PERMIT

Section II.A.3. and Appendix A Table A-3. Treatment Area No. 1 and Treatment Area No. 2. A. Soils:

INTERNATIONAL PAPER
Former Wood Treating Facility, Wiggins MS
1633 South 1st Street, Wiggins MS

Figure 2 Corrections:

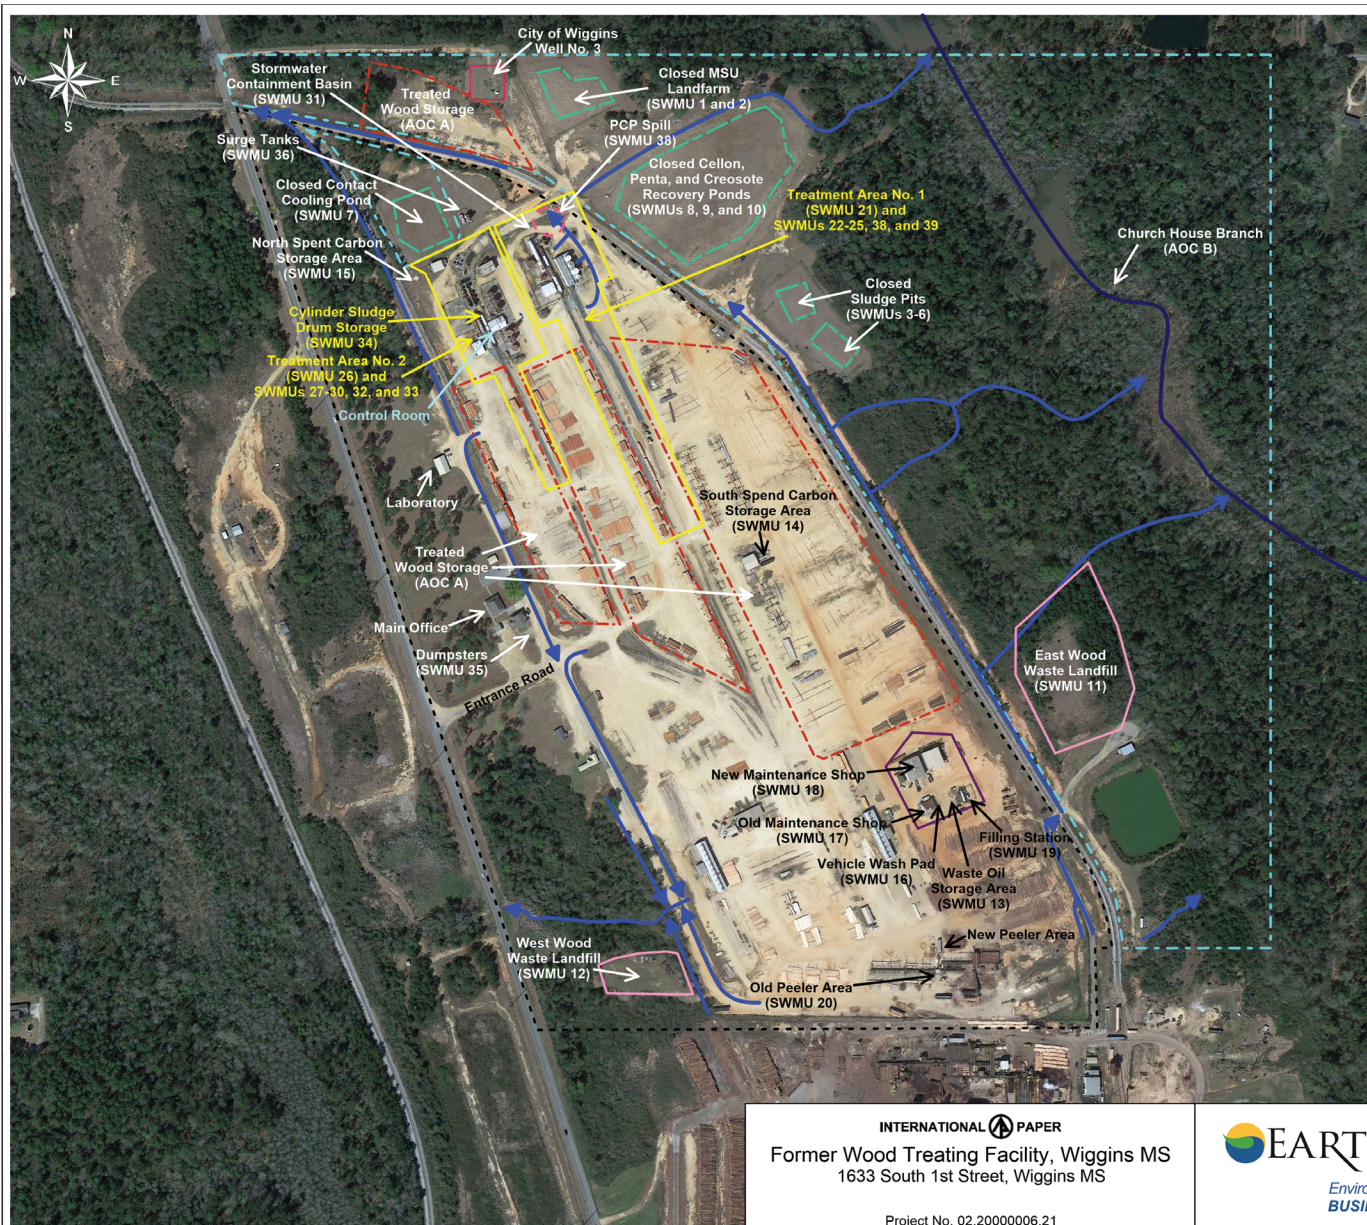
- The City Well should be identified as City Well #3, it is correctly identified on Figure 1.
- The boundaries of the East Wood Waste Landfill SWMU 11 are incorrect, the correct boundaries are shown on Figure 1.
- A corrected **Figure 2** is provided for use by EPA in this Permit.
